ADDENDUM # 002

**Our Lady of Fatima
545 Baldoon Rd
Chatham, ON**

New Exterior Wall Assembly, Universal Washroom and In-coming Water Service Project No. 619-CP1835

June 4th. 2018

ASK-012

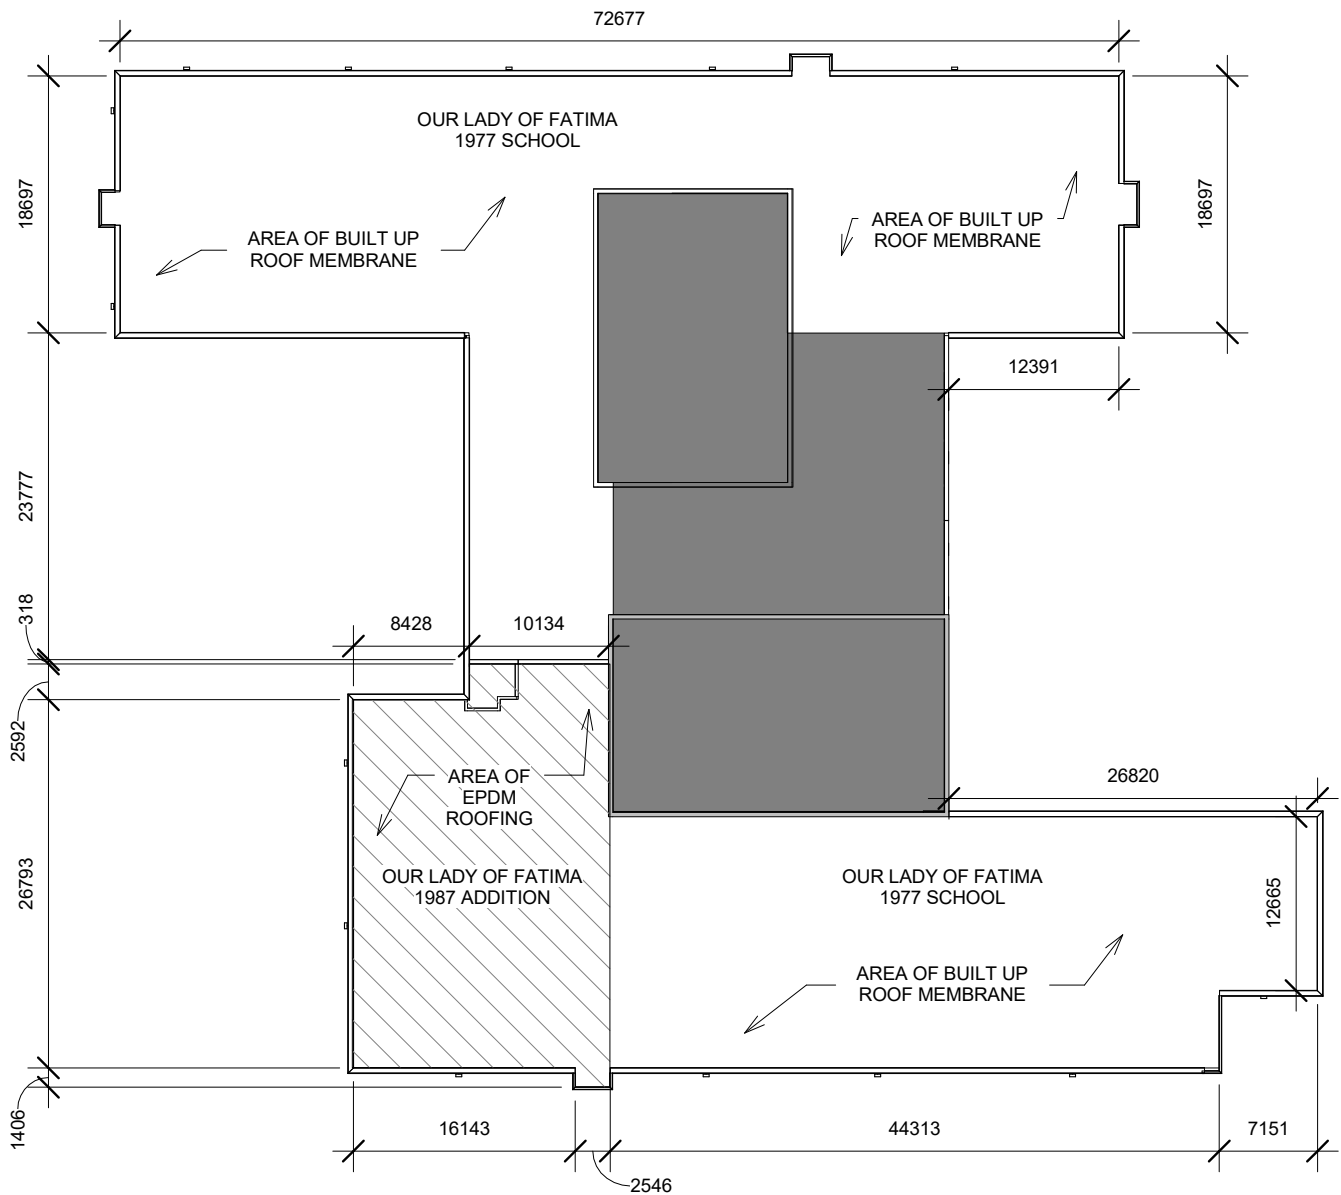
ASK-012 – Reflected Ceiling Demo Plan:

AD200 – Remove & save existing PA system for reinstall. Remove & dispose of louvre and

metal protrusions. Remove existing exterior LED light fixtures and conduits. Cap conduits and return fixtures to the school board.

ASK-014

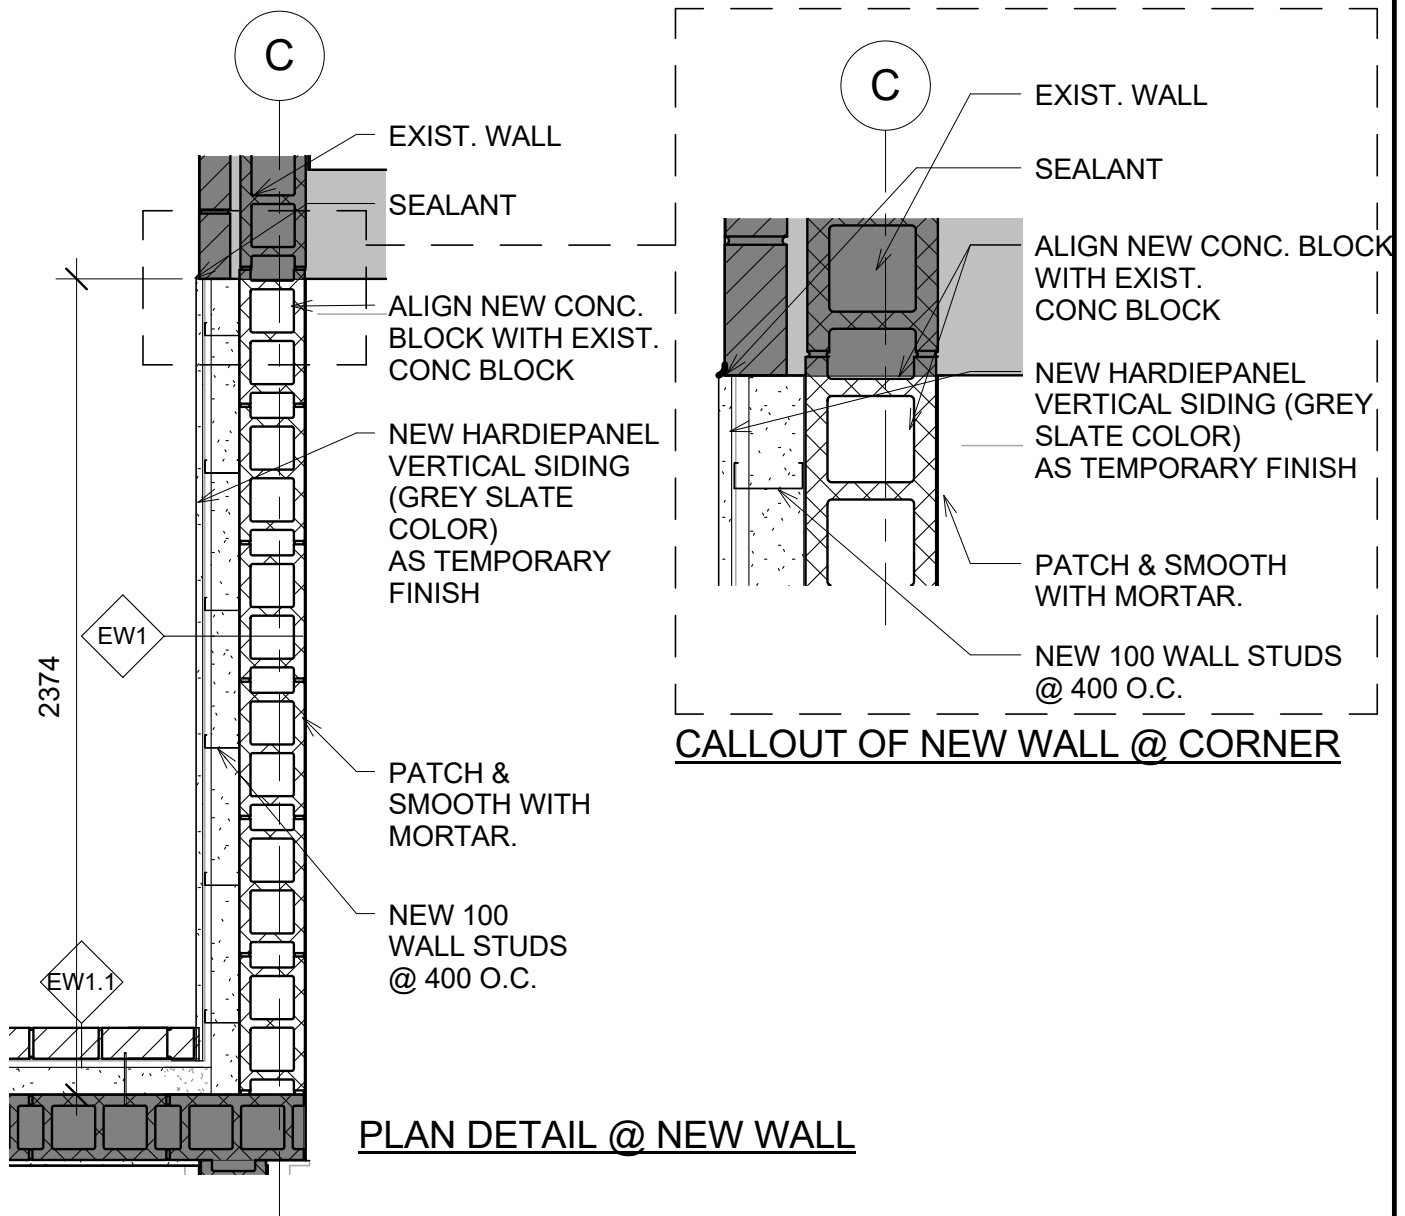
ASK-014 – Roof Plan:

Plan indicating areas of existing roof and roof finish type. Membrane to be applied up sides of roof parapets as per ASK-013 to be lapped with existing membrane, and to be compatible with existing roof membrane system type (EPDM or Built up roof).

NOTE: MEMBRANE TO BE APPLIED UP SIDES OF ROOF PARAPET AS PER ASK-013 TO BE LAPPED WITH EXISTING MEMBRANE, AND TO BE COMPATIBLE WITH EXISTING ROOFING SYSTEM TYPE (EPDM OR BUILT UP ROOF).

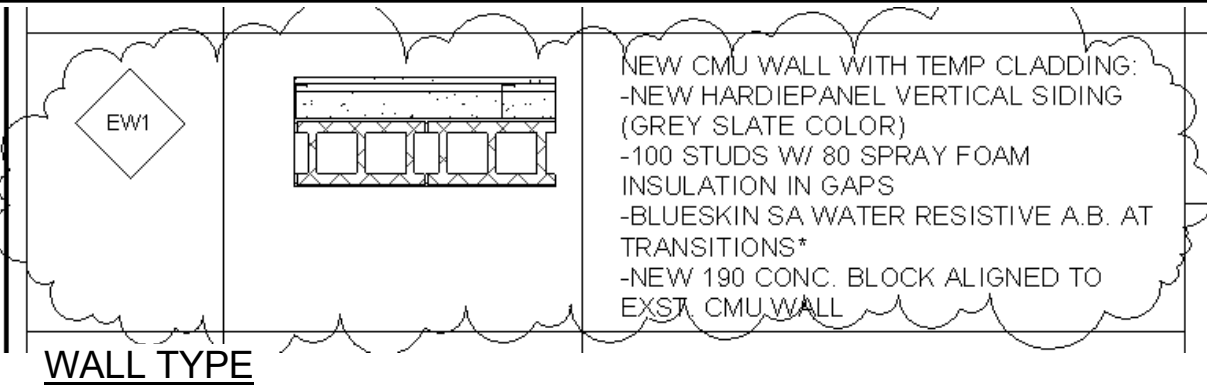
ASK-015 – Revised Wall Type:

New wall to be installed at rear end of the school will have the main core concrete block align with the existing concrete block wall. New studs will be installed with spray foam applied between the studs. New Hardiepanel Vertical Siding shall be applied overtop as a temporary finish. Ensure that sealant is applied between where the existing brick wall finish meets the PT Plywood finish.
